Comments on Covariance Data of JENDL-4.0 and ENDF/B-VII.1

April 22, 2014

M. Ishikawa, JAEA

U-238 Elastic (1/3)

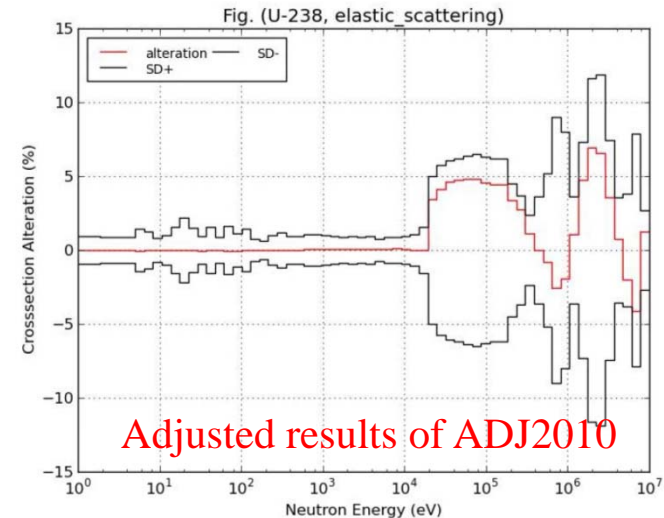
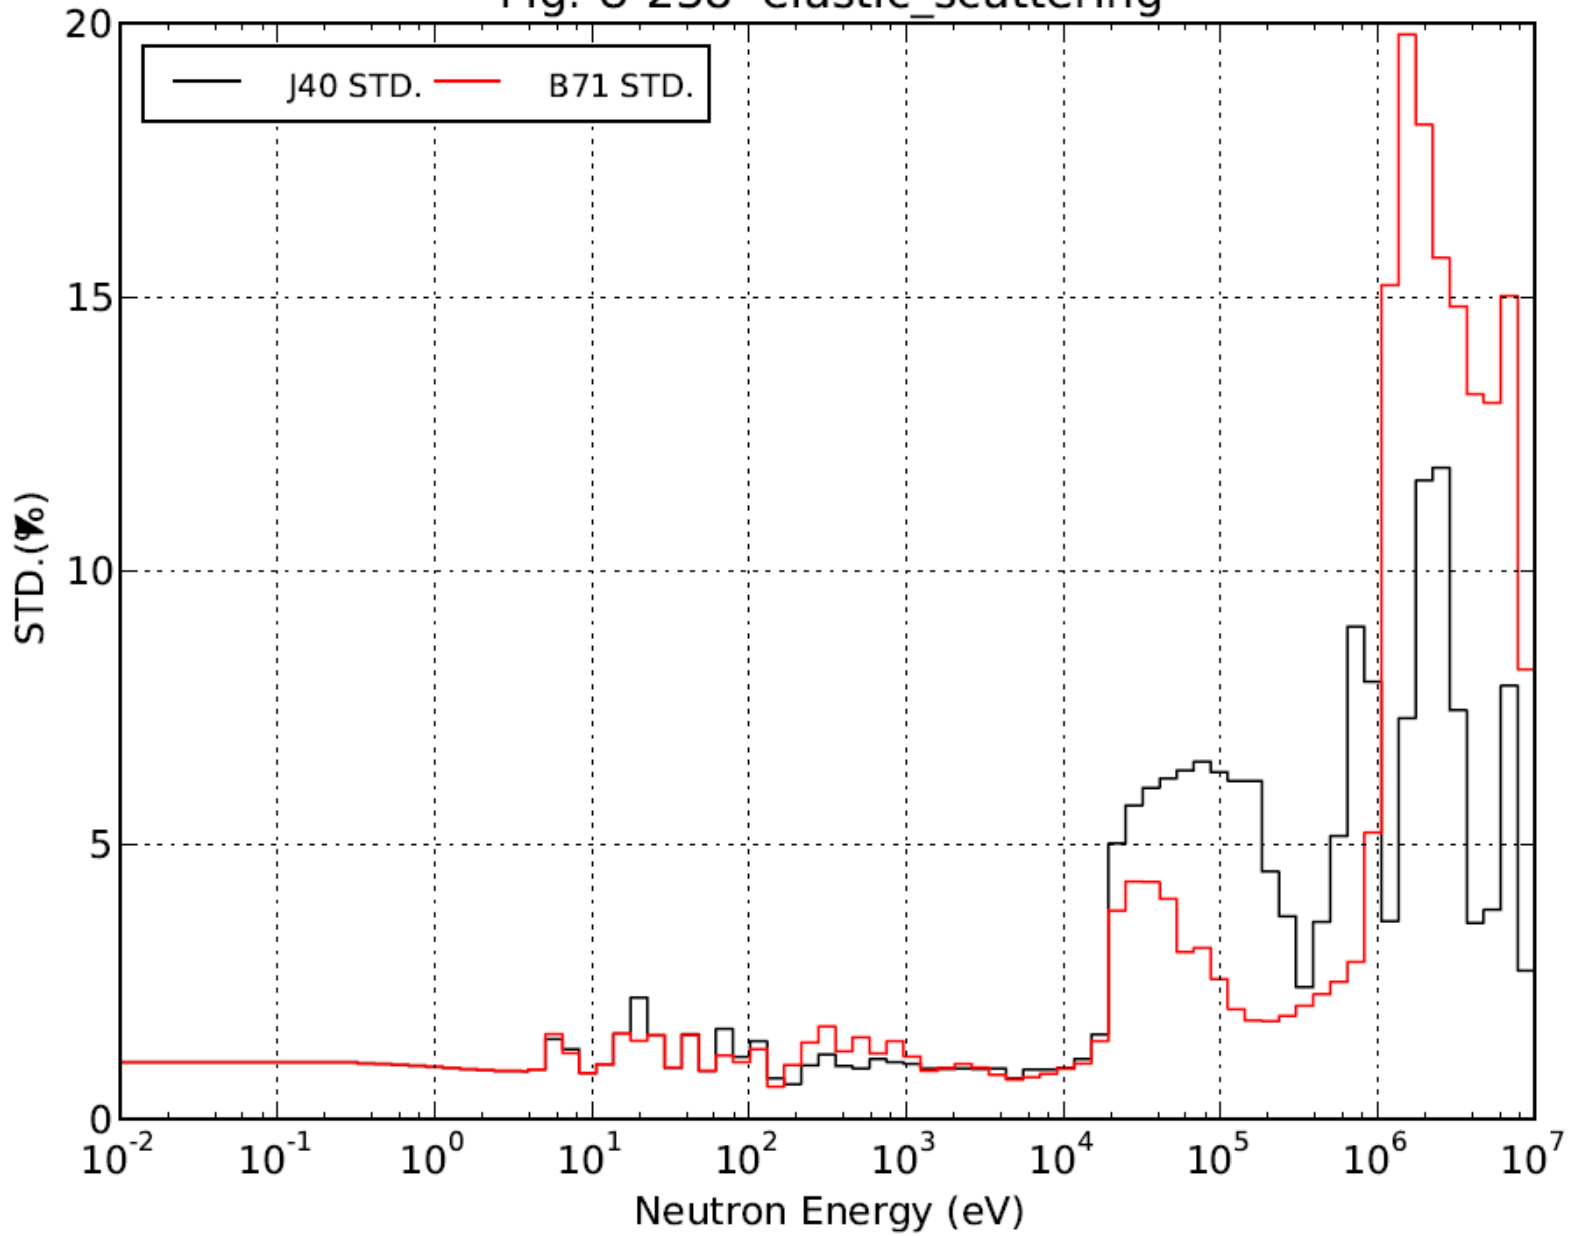
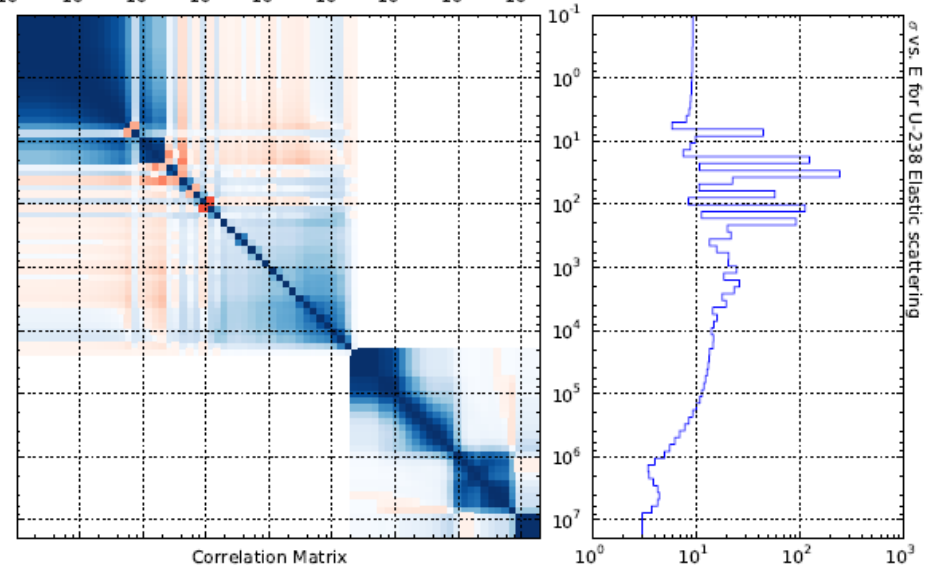
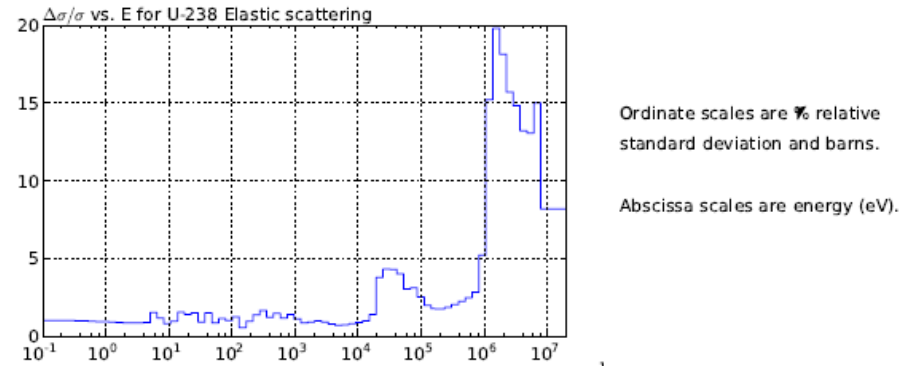
The STD values and shapes are rather similar in both libraries, but the energy regions with **large negative correlations** were found in **JENDL-4.0**, but **NOT in ENDF-7.1**.

The covariance of JENDL-4.0 was evaluated by CCONE-KALMAN^(J-3), and that of ENDF-7.1 by GNASH-KALMAN^(E-3), while both applied the relation of "Elastic=Total - Nonelastic" to evaluate the central cross-section values^(J-3, E-3).

SG39 may ask the **possible reason of the correlation differences** to both **JENDL-4.0** and **ENDF-7.1** evaluators.

Fe-56 Elastic (1/3)

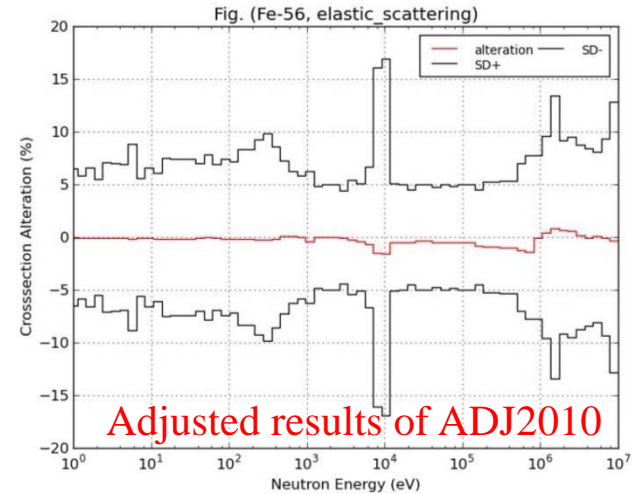
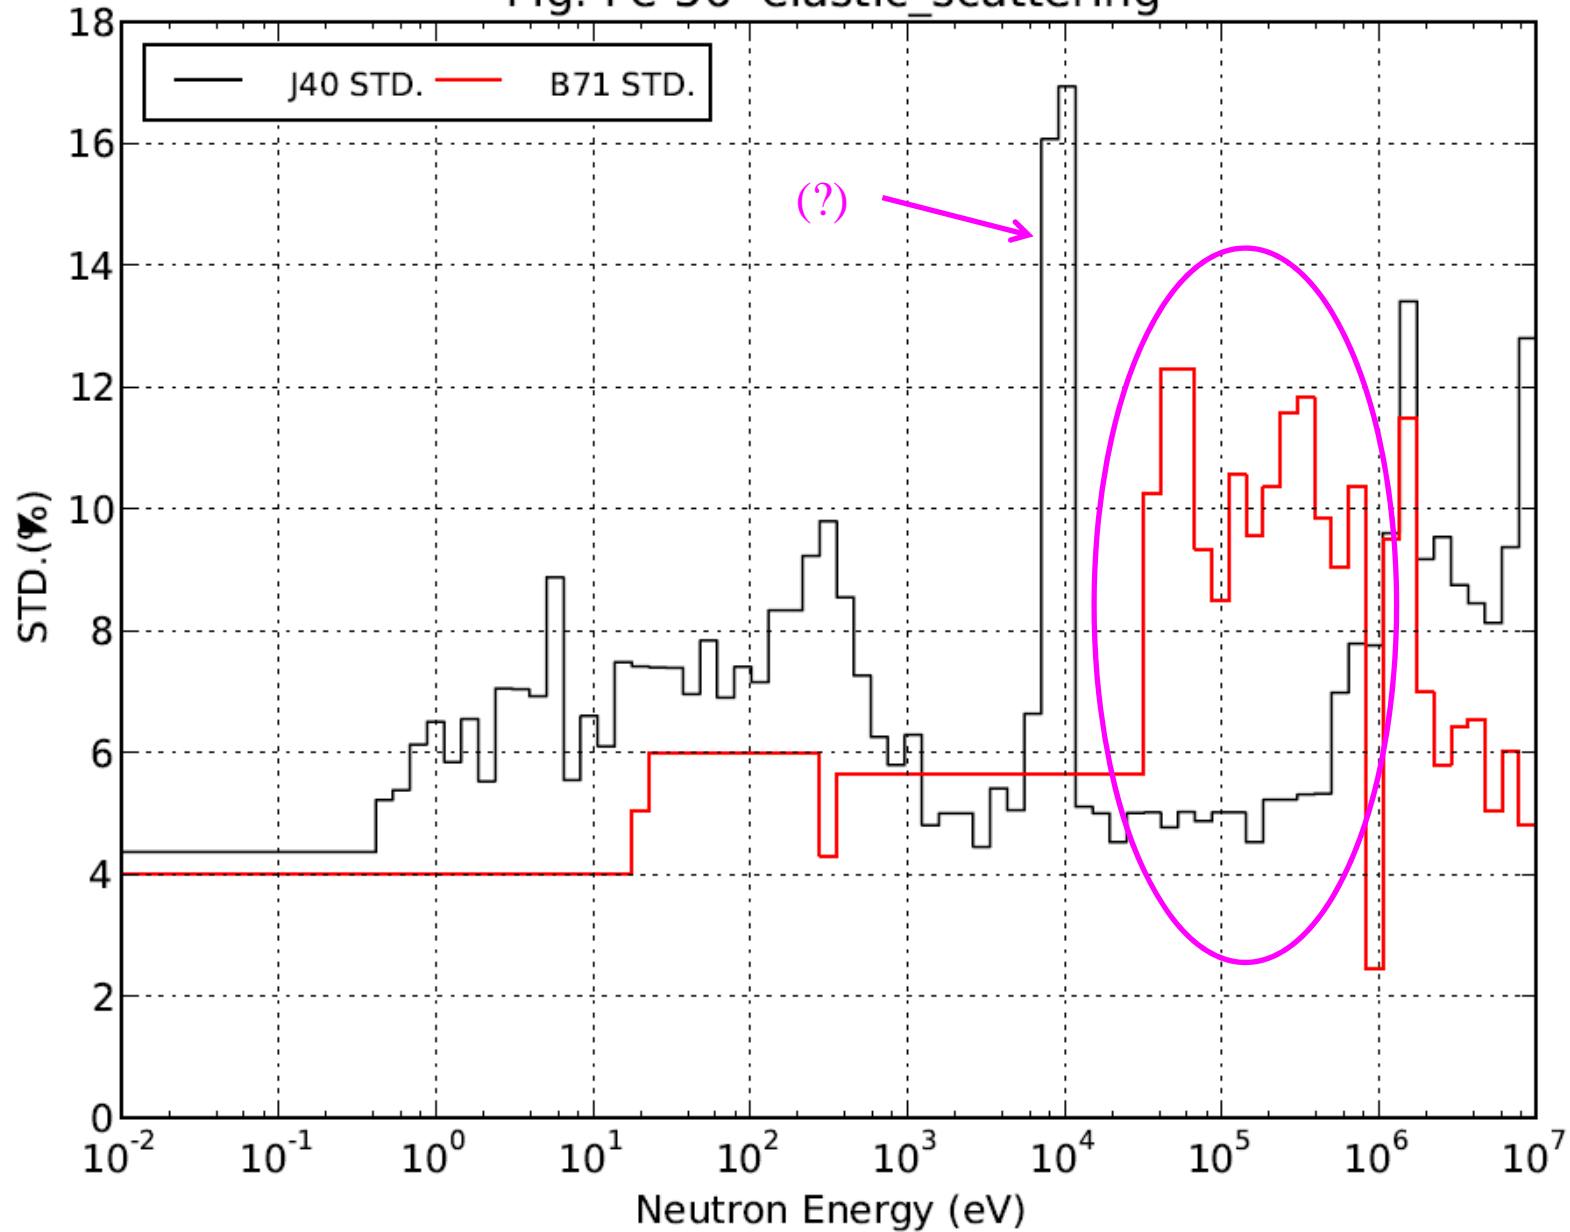
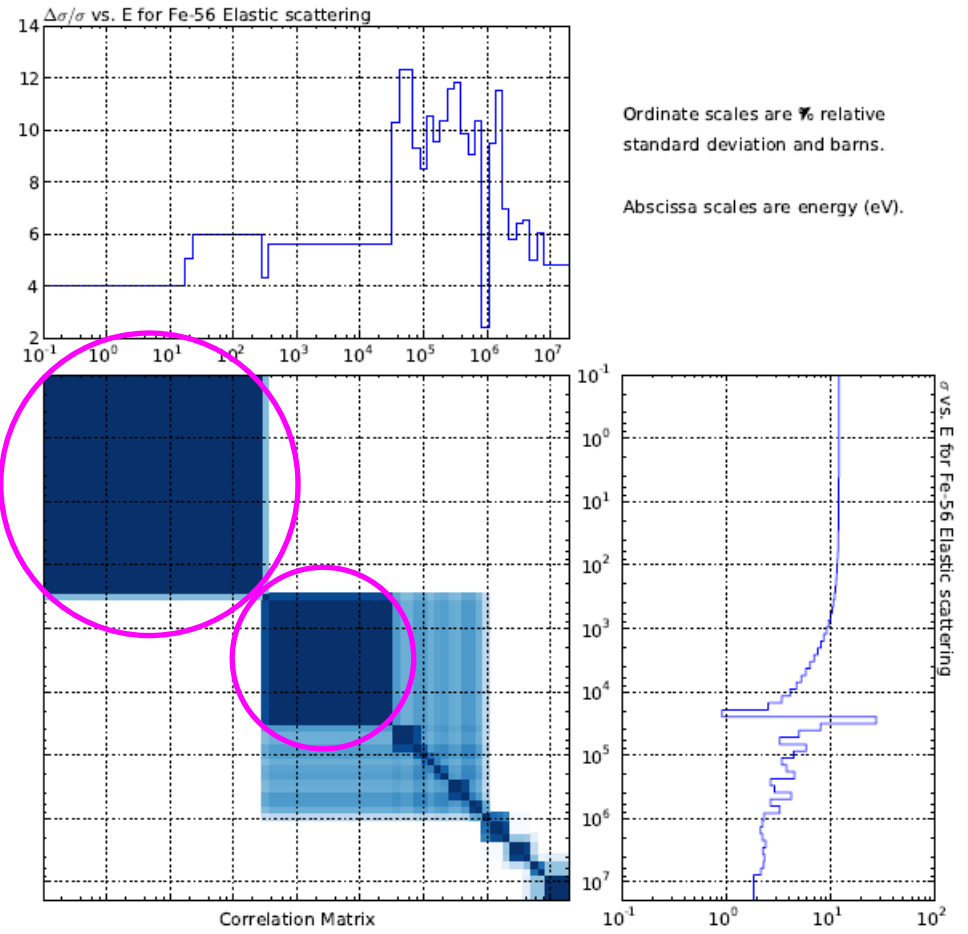
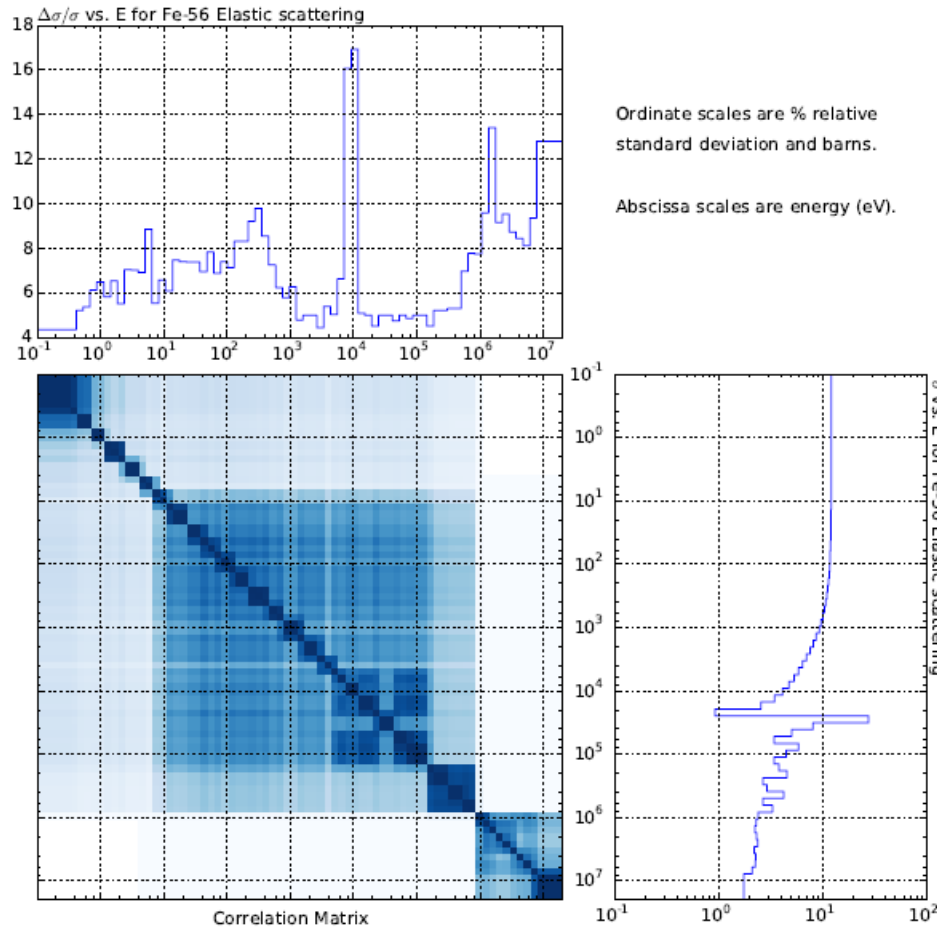
The covariance of ENDF-7.1 in the energy region of 100~300eV and 300eV~30keV shows the complete correlation respectively, but the the STD values are rather similar around 6~8%. Above 30keV, the STDs of both libraries are utterly different. Further, a sharp peak near 10keV appears in JENDL-4.0, but not in ENDF-7.1.

The central cross-sections are almost identical, since they are based on the common resonance parameters evaluated by Froehner in 1990s^(J-5). The covariance of ENDF-7.1 was Kernel approximation with the resonance parameter uncertainty of Mugahabghab^(E-2, p.15), while JENDL-4.0 adopted the least-square calculation of Fe-56 experimental data, and corrected the covariance based on the difference of the least-square central values and JENDL-4.0^(J-3).

SG39 may **ask the reasonableness** of the covariance data to both **JENDL-4.0** and **ENDF-7.1** evaluators.
